UNITED STATES PATENT AND TRADEMARK OFFICE

APPLICATION NO.	FILING DATE	FIRST NAMED INVENTOR	ATTORNEY DOCKET NO.	CONFIRMATION NO.
09/236,373	01/25/1999	BRUCE A. BUHLER	71-673-1	1565

Office Action Summary	Application No. 09/236,373	Applicant(s) BUHLER, BRUCE A.	
	Examiner Carl D. Price	Art Unit 3749

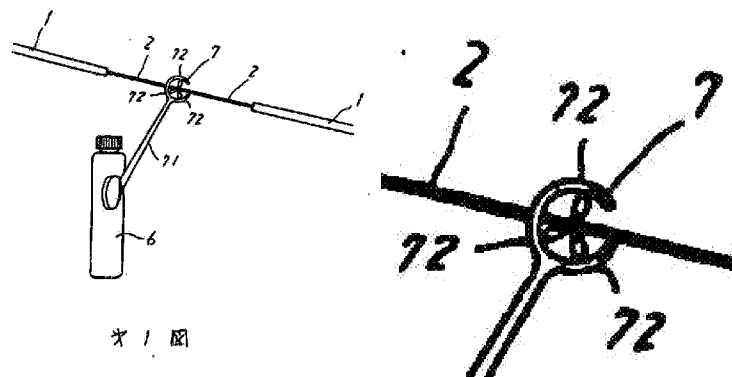
JP 55048713 (Inoue) shows and discloses a loop-form nozzle 7 is connected at its neck part 71 to a small-size flame torch 6 or the like as a heater, which uses butane or acetylene as its fuel. The ends of the loop-form 7 are open and therefore the nozzle is so disposed that a butt face position of two members to be fused are at the center of the nozzle 7. Fusion welding heat is provided when high temperature applied from the three flame spray ports 72, provided along the curved tip profile at an angle of 120°, is applied to the butt face, whereby the butt face is fusion welded and connected.

JP 55048713 (Inoue) shows and discloses the gas pressure from each flame spray port are cancelled out, thus preventing shaft deviation by gas pressure.

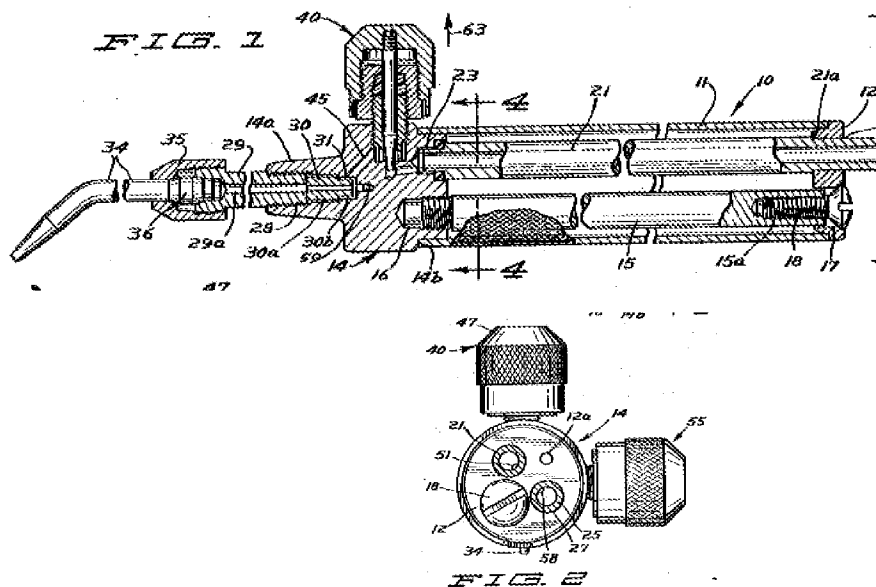
US 3279701 (Falk et al) teaches, from the applicant's same torch head field of endeavor, forming a integral torch head and handle tube (11) to include separate fuel gas and oxygen supply passages (21, 25) therein and control means (40,55) on the torch head and associated with each of the fuel gas and oxygen passages to selectively block or control the flow there through. **Falk et al** includes a tip stem (29) communicating with the fuel and oxygen passages and connected to a tip head (34) having a flame orifice.

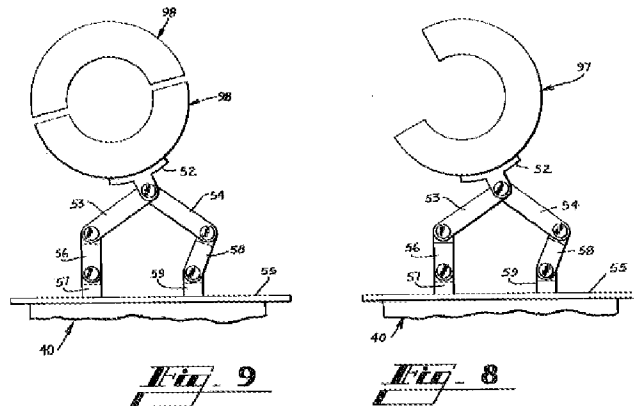
US 4231777 (Lynch et al) teaches (figures 8,9; column 6,lines 43-50), , from applicant's the same torch head field of endeavor, alternative or selectively forming the semi-circular segment of the burner head to be **greater than 180 degrees**.

Figure 5

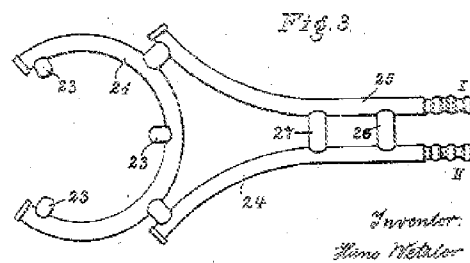
FIG. 5 shows a side view of an exemplary nozzle plate 16. All of the interleaved grooves 32 and 36 in groups 29 and 29' are radially directed at common line 81 while the slots in groups 30, 30' and 31, 31' are radially directed at the common lines 82 and 83, respectively. Common line 82 is on the centerline of the tube 90 while common lines 81 and 82 are on the outer surface of the tube. Although each of the three groups are directed towards different common lines in the exemplary embodiment **it may be advantageous to direct the grooves of several groups at the same common line when the number of groups or the size of the tube increases.**

FIG. 5.

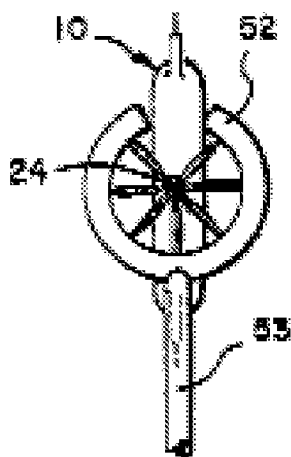
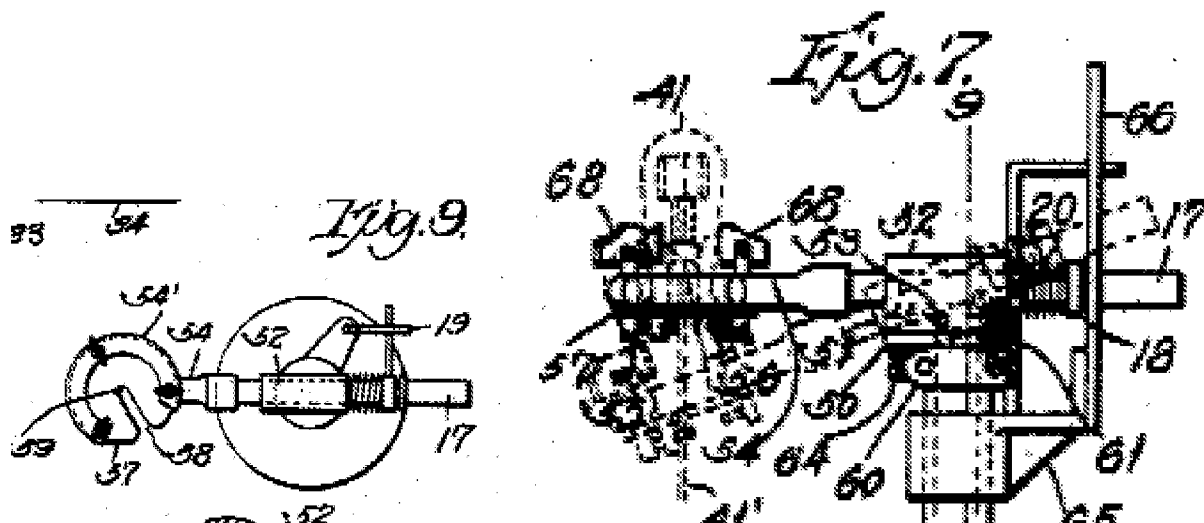
US 3188778 (Wiener et al) teaches (figure 5; column 3, line 69 - column 4, line 2 and column 4, lines 60-72), from applicant's the same torch head field of endeavor, selectively forming the semi-circular segment (52) of the burner head to accommodate, through an arcuate distance to defined a gap to facilitated the insertion of the member to be heated into the interior of the tip head through a side portion of the tip head.

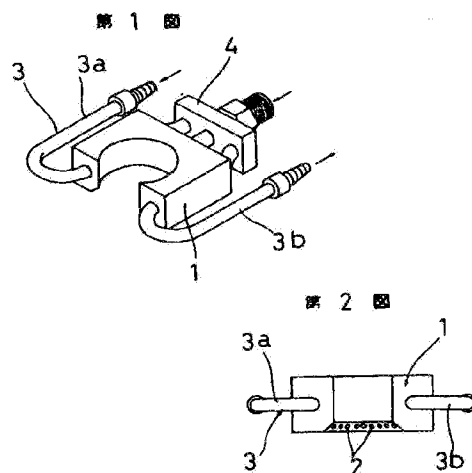
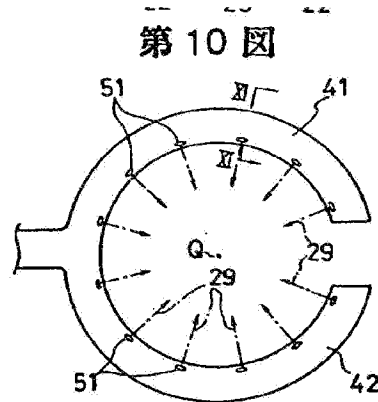
Japanese 58-142310 (figures 1-2) and **Japanese '570 (figure 10)** show and/or disclose torch heads and handles having separate fuel gas and oxygen supply passages therein and control means on the torch head and associated with each of the fuel gas and oxygen passages to selectively block the flow there through. **Japanese '310** includes a tip stem (4) communicating with a fuel/oxygen passage and connected to an arcuate shaped tip head (Figures 1,2) and having at least a first, second and third angularly spaced orifices (2) which open toward a common point. And, **Japanese '310** discloses and shows flames directed angularly from a first burner head plane to a second heater member intersecting plane (figure 2).

Japanese '570 shows at least a first, second and third angularly spaced orifices (2) which open toward a common point.

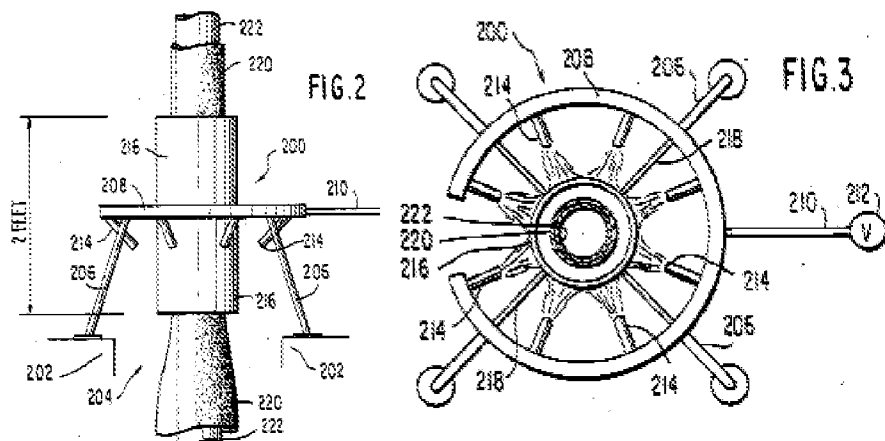
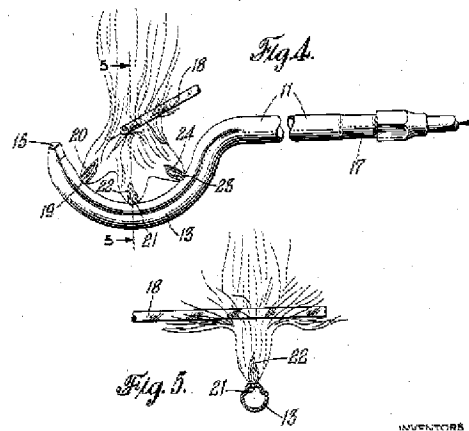
US 4671833 (Bradford) discloses nozzles 214 have a width of 2 inches, have a length of 5 inches and are eight in number, generally spaced around gas ring 208. Preferably eight flame nozzles 214 are used, but the number of flame nozzles 214 can readily be from **three** to ten or more, keeping in mind that uniformity of heating sleeve 220 and pipe 222 is what is sought. Preferably nozzles 214 are set at an angle of 40 to 60 degrees to the longitudinal axis of vertical casing 216. Nozzles 214 are set at such an angle to make sure that the end of casing 216 is heated to the desired temperature so as to quickly heat shrink heat-shrinkable sleeve 220 to a substantial amount as it is coming into casing 216.

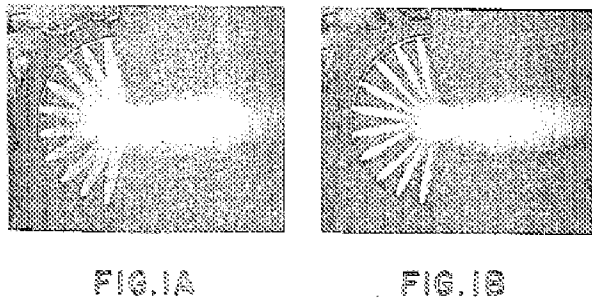
US 2608031 (Barnes et al) (of record) which show an arcuate torch head (13) and *only three* equally spaced flame ports (23) arranged to produce a *complete* circumferential flame array for *completely* heating the entire circumferential extent of the member (18), even though the arcuate member extends only 180 degrees.
